PLAN CHANGE 75
TE PUKE FLOODABLE
AREAS AND AREA 3
STRUCTURE PLAN REVIEW
DECISION REPORT

*Western Bay of Plenty
District Council*

April 2017

8.2 Te Puke Area 3 Structure Plan – Infrastructure (Decisions version)

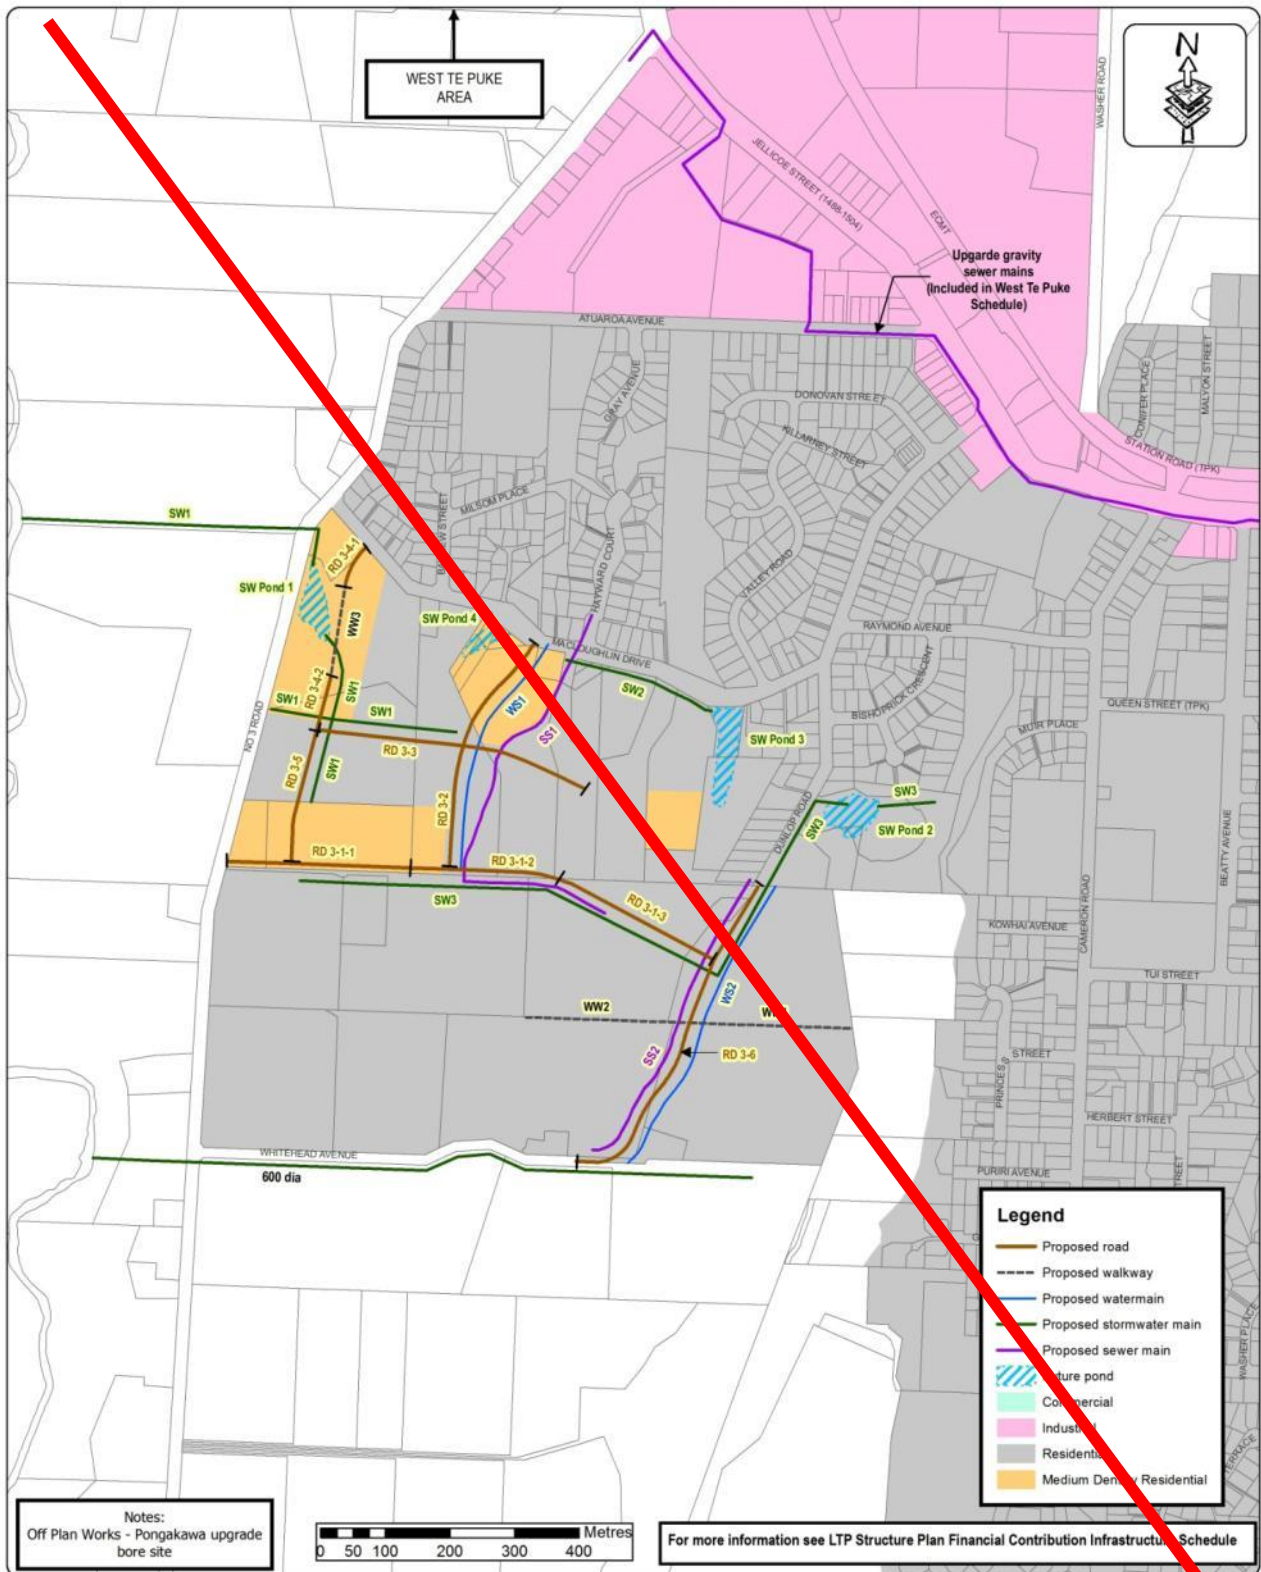
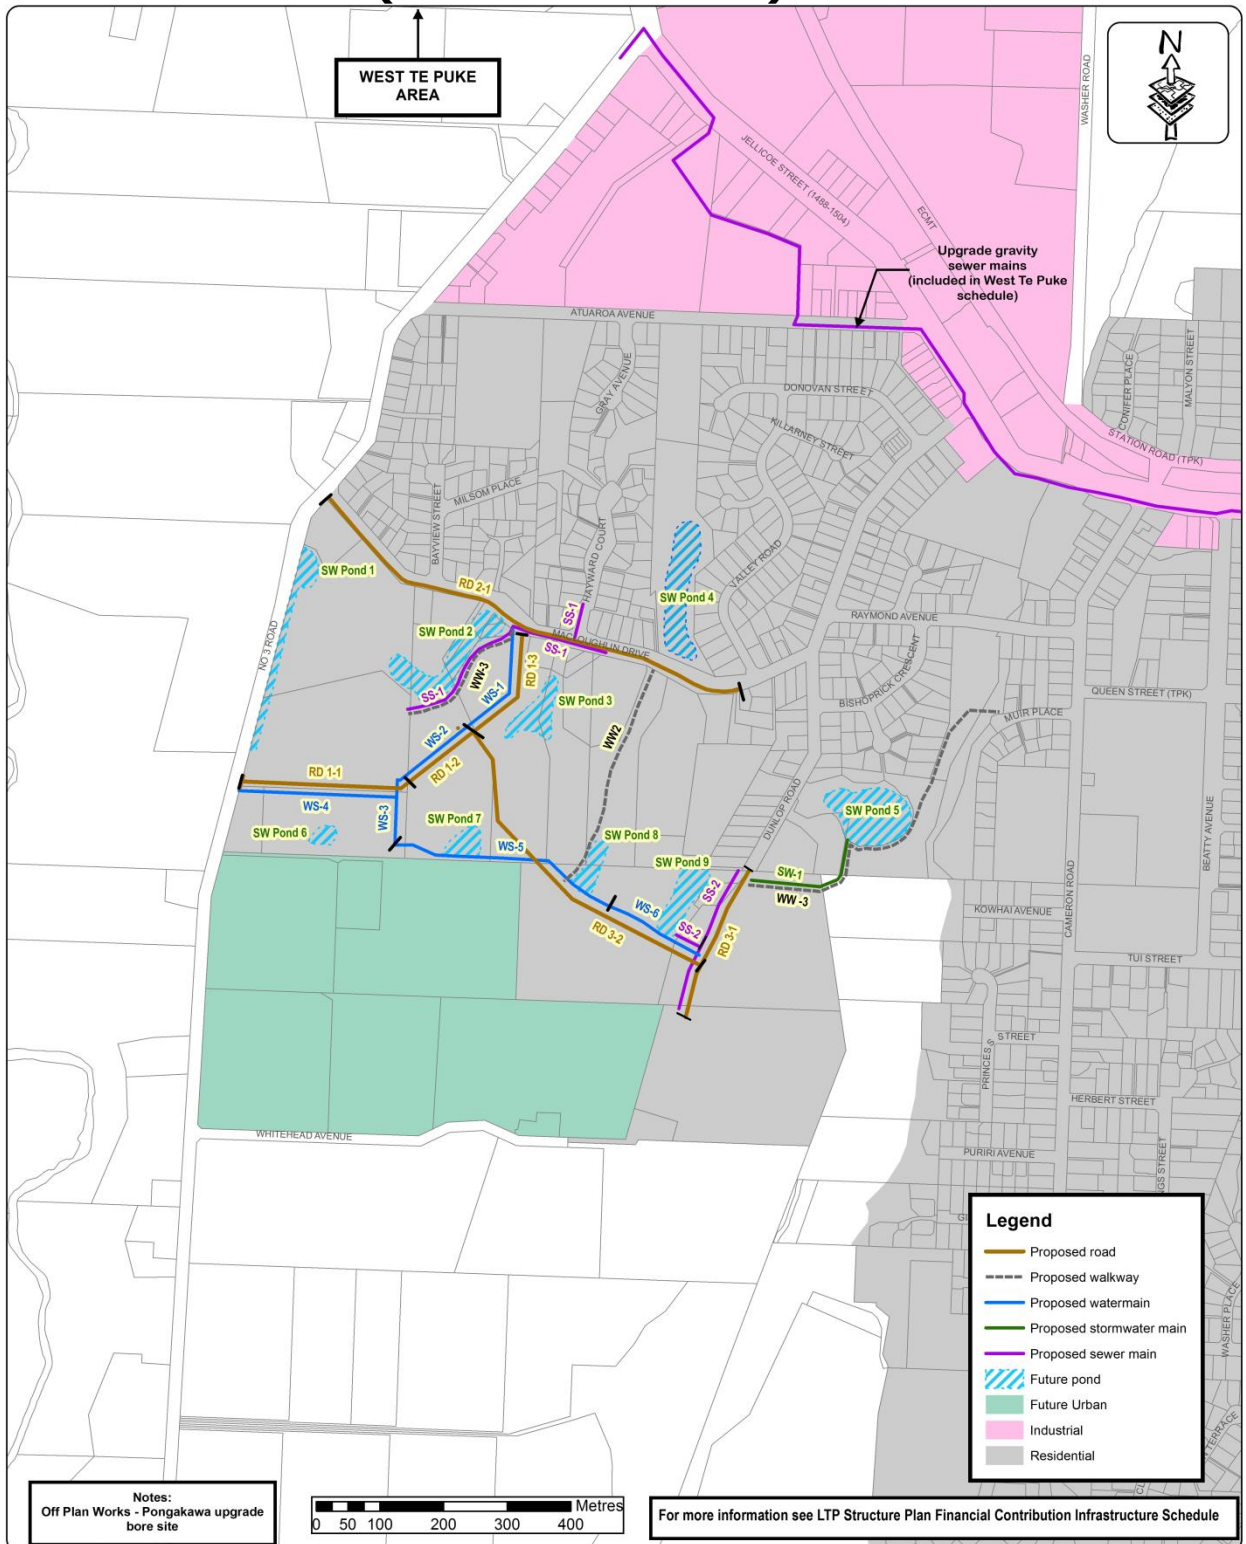
2. Stormwater pond SW4 be retained as notified.
3. Except for the specific changes included in 1 and 2 above, the structure plan roads and utilities as per Attachment C of the Section 32 report be retained as notified.

- b) The location and capacity of the proposed stormwater ponds are based on the current contours. It is possible to re-contour certain areas and as a result change the current stormwater catchment boundaries. Standard practice is to resolve these issues during a subdivision consent. At the time of the consent, detailed consent specific information is available (e.g. finished contour levels, lot sizes and percentage of hard stand). In the absence of a subdivision consent, Council cannot assume that the property will be re-contoured and the ponding area along No 3 Road will not be required.

- c) Stormwater pond SW4 will be required in future due to limited suitable storage capacity upstream. Staff to continue with the discussions to purchase the land required for SW4.

[More detailed/specific investigations, calculations and design will be undertaken during a specific subdivision or land use consent. This may demonstrate that a better outcome can be achieved than what is included in the structure plan. As a result, the infrastructure included in the structure plan will be updated to reflect the actual infrastructure after the issuing of S224 certificate or code of compliance certificate.](#)
